# Access Compliance Report

## Public Rights-of-Way

### (Curb Ramps)

| Intersection ID: 12925 | Main Street: S_CHURCH_ST | Cross Street: W_CARSON_BV | Location: E            |

| ADA ID: 50C0CA963C1D   | Ramp Type: Directional1  | Initial Pass/Fail: Pass   | Overall Compliance: No |

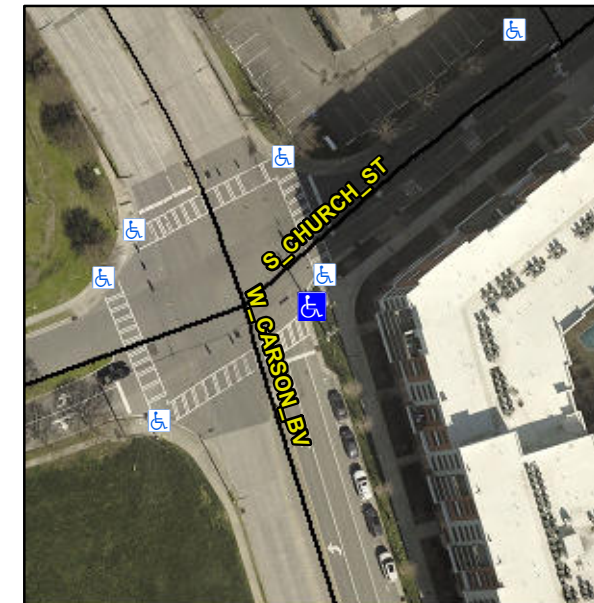
**R304.5.3, R304.2.1, R304.5.2**

| Compliance | Description           | Data  | Compliance | Description                 | Data |
|------------|-----------------------|-------|------------|-----------------------------|------|
| N/A        | Ramp Length (in)      | 75.0  | No         | Grade Break?                | No   |
| No         | Ramp XSlope (%)       | 3.5   |            |                             |      |
| No         | Landing Length (in)   | 45.0  | Yes        | DWS Provided?               | Yes  |
| No         | Landing X Slope (%)   | 2.6   | Yes        | DWS Full Width?             | Yes  |
| Yes        | Gutter Lip Ht (in)    | 0.0   | No         | Gutter X Slope (%)          | 4.4  |

**Remove & Replace Entire Ramp.  
Remove & Replace Gutter.**
